UNITED STATES PATENT AND TRADEMARK OFFICE
CERTIFICATE OF CORRECTION

PATENT NO. : 6,032,898
APPLICATION NO. : 08/705326
DATED : March 7, 2000
INVENTOR(S) : LaCount et al.

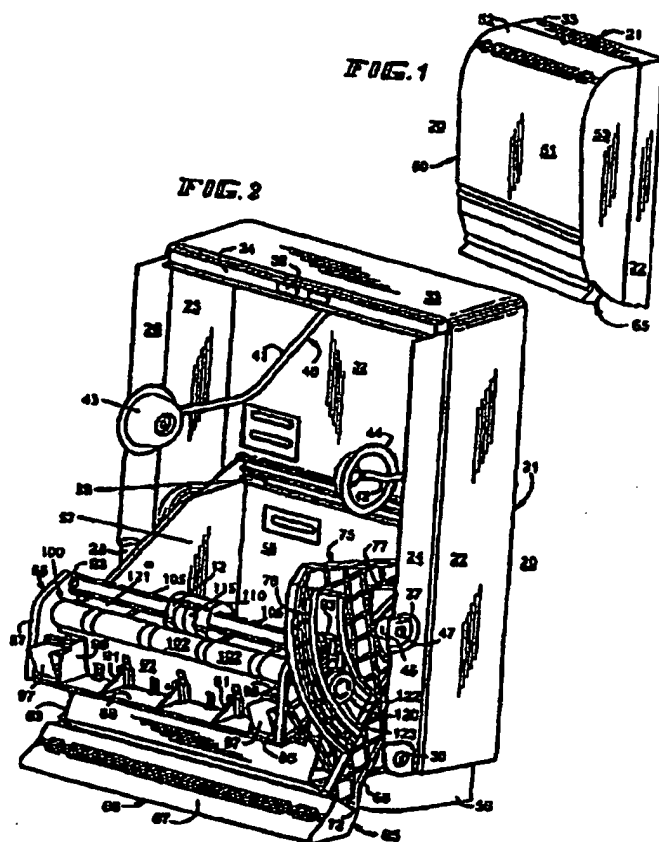
In the drawings, sheet 1, Fig. 2, reference numeral "22" on the sidewall of outwardly extending flange 24 should be deleted and reference numeral --27-- should be applied to the stamped portion;

In the drawings, sheet 1, Fig. 2, reference numeral --43-- should be applied to the left-hand side hub of the paper roll holder assembly 40; reference numeral --58-- should be applied to the rear wall of the chassis 55; reference numeral --57-- should be applied to the left-hand side spaced parallel side wall of chassis 55; reference numeral --38-- should be applied to the clip extending from the rear wall 32 of the housing 21.

In the drawings, sheet 1, Fig. 2, reference numeral --121-- should be applied to the drive roller segments of the drive roller 120.

In the drawings, sheet 1, Fig. 2, reference numeral --105-- should be applied to the transfer roller assembly; reference numeral --106-- should be applied to the shaft 106 of the transfer roller assembly 105; reference numeral --110-- should be applied to the transfer mechanism; reference numeral --112-- should be applied to the indented or removed portion of the cylindrical portion 111 of the shaft 106; reference numeral --115-- should be applied to the snap clip which receives the indented or removed portion 112 of the cylindrical portion 111 of the shaft 106.

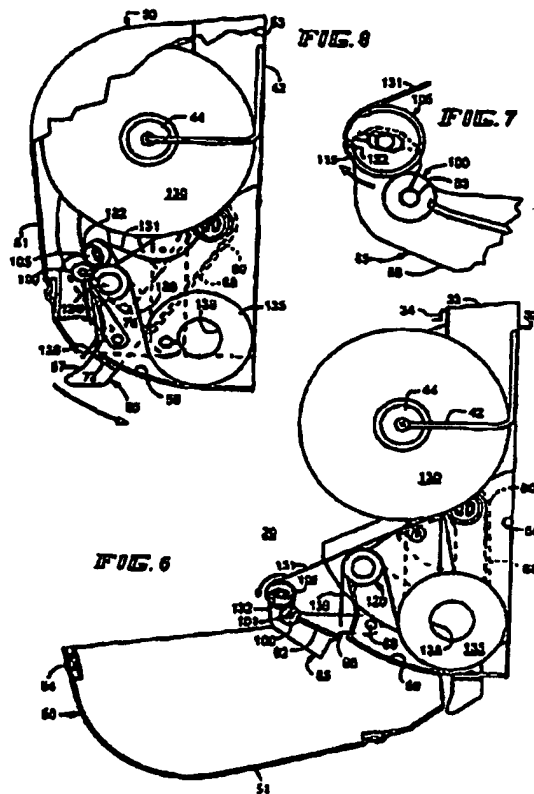
In the drawings, sheet 3, Fig. 6, the reference numeral "50" (not the reference numeral "50" pointing to the cover) should be deleted and reference numeral --51-- should be applied to the front panel of the cover 50.

FIG. 10

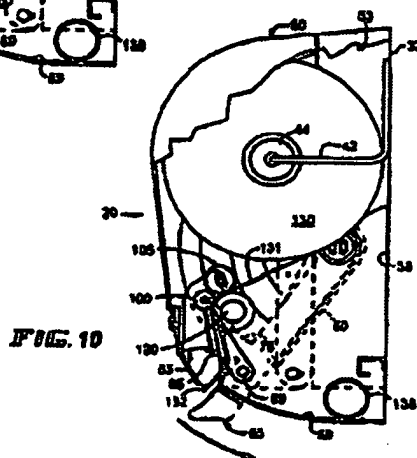
In the drawings, sheet 4, Fig. 10, the reference numeral "131" pointing to the free end of the flight of paper 131 should be deleted and the reference numeral --132-- should be applied to the free end of the flight of paper 131.

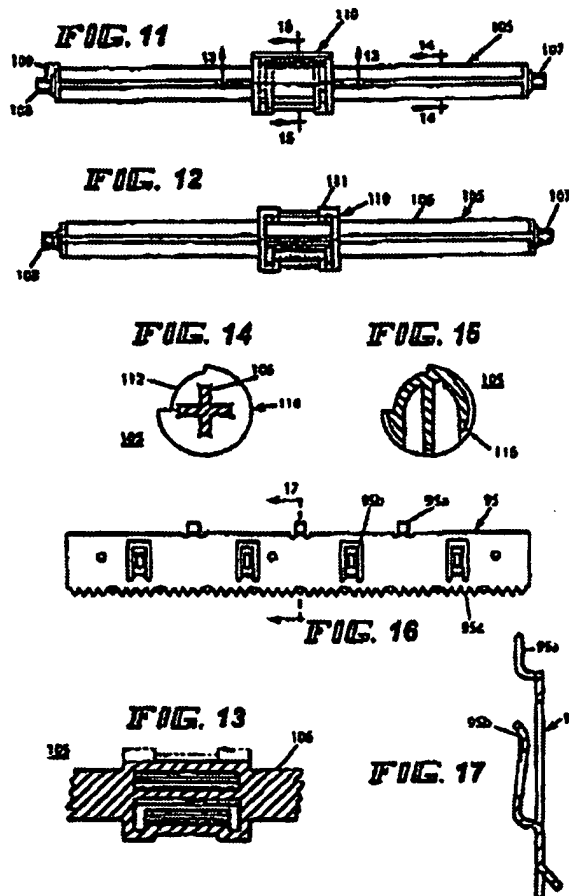
In the drawings, sheet 5, Fig. 11, reference numeral --105-- should be applied to the transfer roller assembly; reference numeral --107-- should be applied to the journal on the right-hand end of the transfer roller assembly 105; reference numeral --108-- should be applied to the journal on the left-hand end of the transfer roller assembly 105; reference numeral --109-- should be applied to the stop plate on journal 108; and reference numeral --110-- should be applied to the transfer mechanism positioned generally centrally of the shaft of the transfer roller assembly 105.

In the drawings, sheet 5, Fig. 12, reference numeral --105-- should be applied to the transfer roller assembly; reference numeral --106-- should be applied to the shaft of the transfer roller assembly 105; reference numeral --107-- should be applied to the journal on the right-hand end of the transfer roller assembly 105; reference numeral --108-- should be applied to the journal on the left-hand end of the transfer roller assembly 105; reference numeral --110-- should be applied to the transfer mechanism positioned generally centrally on the shaft 106; and reference numeral --111-- should be applied to cylindrical portion of the shaft 106.

In the drawings, sheet 5, Fig. 13, reference numeral --105-- should be applied to the transfer roller assembly; and reference numeral --106-- should be applied to the shaft of the transfer roller assembly.

In the drawings, sheet 5, Fig. 14, reference numeral --105-- should be applied to the transfer roller assembly; reference numeral --106-- should be applied to the shaft of the transfer roller assembly 105; reference numeral --110-- should be applied to the transfer mechanism positioned generally centrally of the shaft 106; and reference numeral --112-- should be applied to the indented or removed portion of the cylindrical portion 111 of the shaft 106.

In the drawings, sheet 5, Fig. 15, reference numeral --105-- should be applied to the transfer roller assembly; and reference numeral --116-- should be applied to the groove or receptacle of the cylindrical portion 111 of the shaft 106.

In the drawings, sheet 5, Fig. 16, reference numeral --95-- should be applied to the tear bar; reference numeral --95a-- should be applied to the tabs of the tear bar 95; reference numeral --95b-- should be applied to the clips of the tear bar 95; reference numeral --95c-- should be applied to the serrated edge of the tear bar 95; and section line --17--17-- should be added at the middle portion of the drawing at the top and bottom thereof.
